## **Upcoming changes to IMC 0305, “Power Reactor Assessment Program”**

## FAQ

Performance Indicator: IE04 - Unplanned Scram with Complications

FAQ 09-04

Figure D-1. The Physical Boundary of Outside Management Control

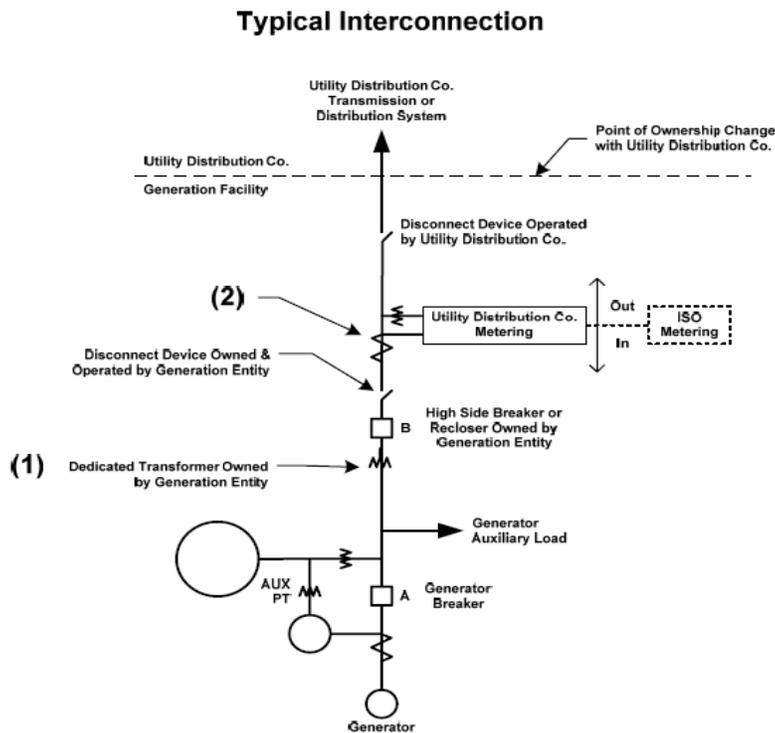
This FAQ seeks clarification to the Unplanned Power Changes Per 7000 Critical Hours Performance Indicator guidance. There has been industry discussion as to whether or not activity and equipment in an local electrical switchyard at a nuclear facility is under the direct control of the nuclear plant management and within the scope of this Performance Indicator. Revision 5 of NEI 99-02 page 15 lines 8-10 state: ***“Power changes directed by the load dispatcher...for grid stability, or for nuclear plant safety concerns arising from external events outside control of the nuclear unit are not included in this indicator. However, power reductions due to equipment failures that are under the control of the nuclear unit are included in this indicator.”***

NEI 99-02 does not specifically define “outside the control of the nuclear unit.” However, this terminology could be interpreted consistently with other industry uses of the same terminology. The IEEE 762 definition of “outside the control of plant management” is incorporated into the North American Electric Reliability Corporation’s (NERC) Generation Availability Data System (GADS) reporting.

NRC REG Guide 1.16 (Monitoring the Effectiveness of Maintenance at Nuclear Power Reactors) provides guidance when interpreting the definition of “outside the control of plant management, as it pertains to the Maintenance Rule. Under the Regulatory Position Section 3 (Inclusion of Electrical Distribution Equipment), RG 1.16 states: “Maintenance activities that occur in the switchyard can directly affect plant operations; as a result, electrical distribution equipment **out to the first inter-tie with the offsite distribution system** (i.e., equipment in the switchyard) should be considered for inclusion as defined in 10 CFR 50.65(b).” In many cases, the first inter-ties to the offsite distribution system are the Main Generator Output Breakers in the switchyard.

To clarify the physical boundary for “outside the control of nuclear plant management,” the following statement will be added to NEI 99-02, page 15, after line 12:

11 However, power reductions due to equipment failures that are under the control of the nuclear  
12 unit are included in this indicator. **For the purposes of this performance indicator, switchyard electrical distribution equipment and maintenance beyond the first inter-tie with the offsite distribution system is not considered “under the control of the nuclear unit” when the equipment is not owned by the nuclear operating company, and the maintenance is being performed by personnel other than nuclear operating company employees. Transients caused by work activities performed by nuclear operating company employees in the switchyard are considered within the scope of this indicator.**
